Soane Point,  
3-10 Market Place,  
Reading  
**Planning Gateway One**  
**Fire Statement**

23<sup>rd</sup> September 2022

BB-FST-11064-OF-0B

Drawing Title  
Proposed Fourth Floor Plan  
PLANNING

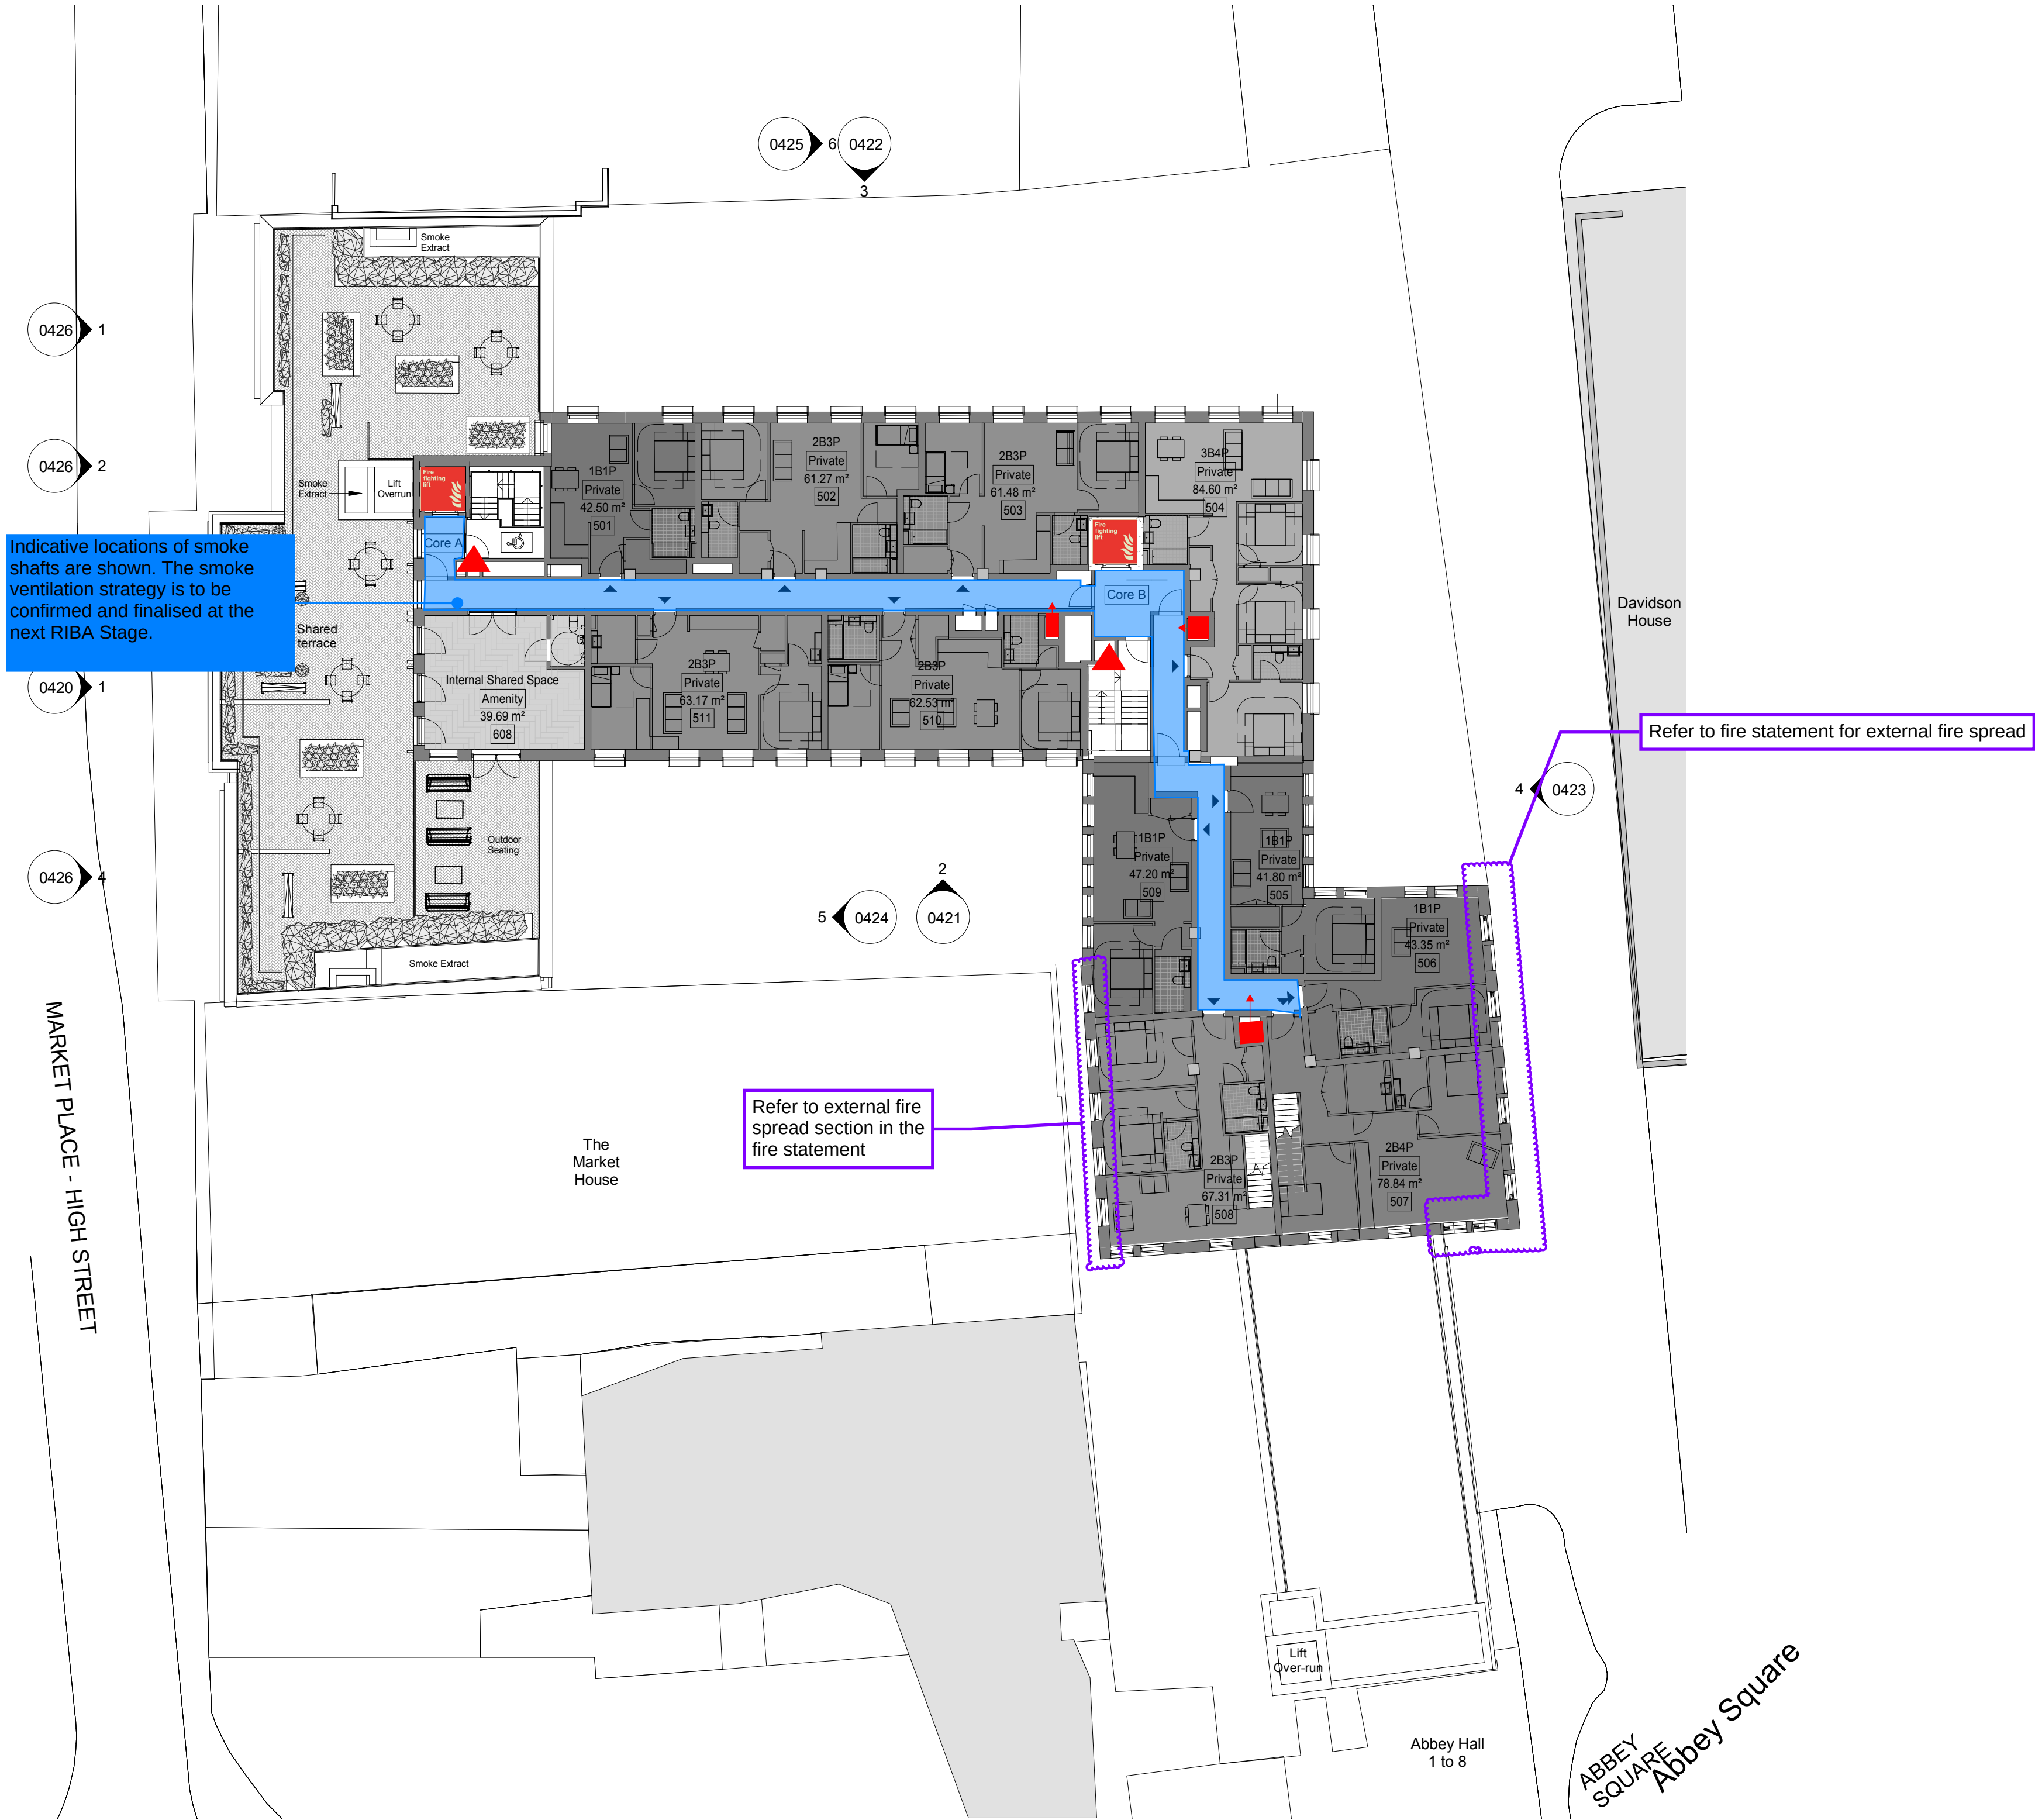
In accordance with BS 9991:2015. If all apartments are provided with sprinkler protection, single direction travel distance can be up to 15m and 60m where there are alternative directions of escape.

Where these distances are extended an alternative engineered solution will be required to be proposed and Computational Fluid Dynamics analysis will be required to be undertaken at the detailed design stage to validate the performance of the proposed smoke ventilation system i.e. mechanical ventilation.

Indicative mechanical smoke shafts, smoke ventilation provisions and cross corridor doors has been highlighted in the mark ups.
